# ***SURVEILLANCE PLAN FOR THE LONDON ROAD FACILITY***

Report No. 94009/G-125  
August 22, 1995

Figure 2 - Survey/Sampling Locations for Abandoned Lateral

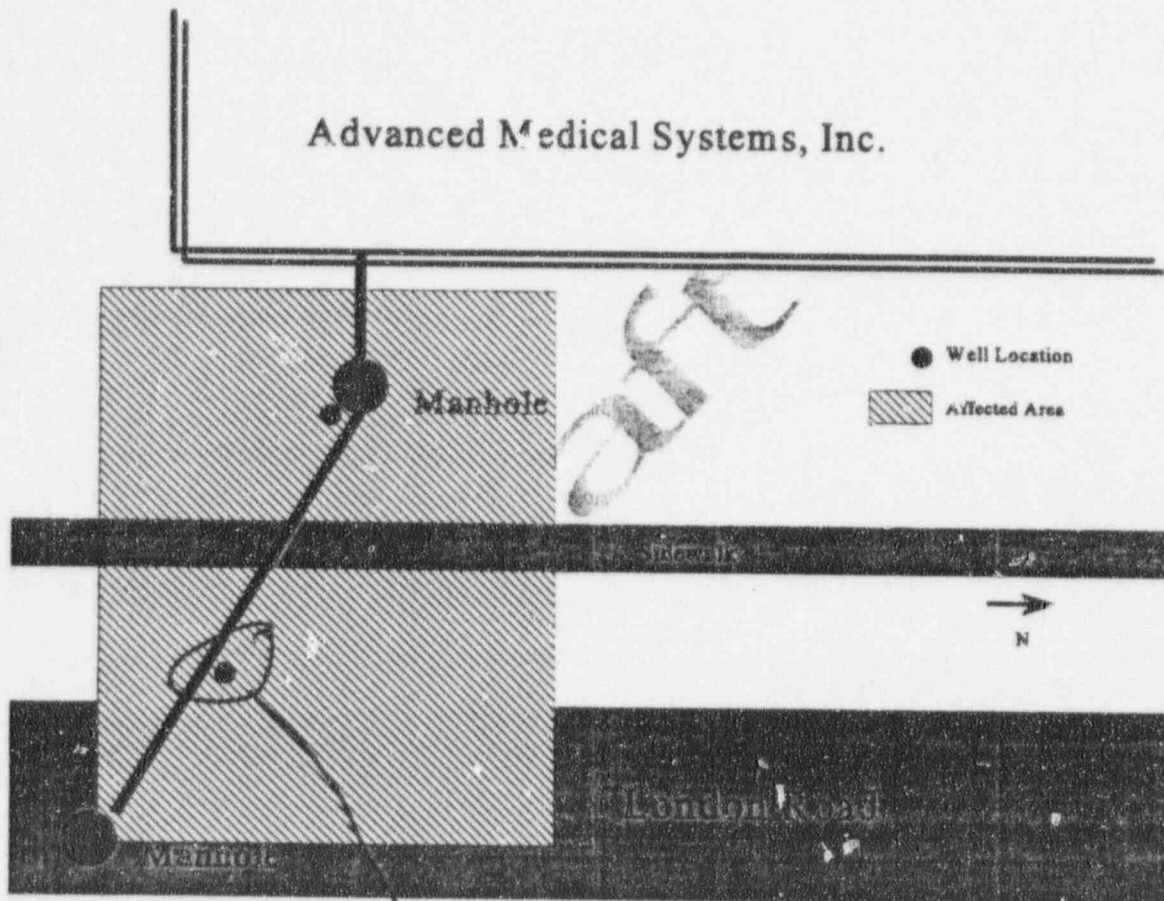
↓ This location subject to  
change. If permission to drill  
in the public right of way cannot  
be obtained, an alternate well  
point will need to be determined  
(This location is in the "Tree Lawn")

RTM 8-24-95.
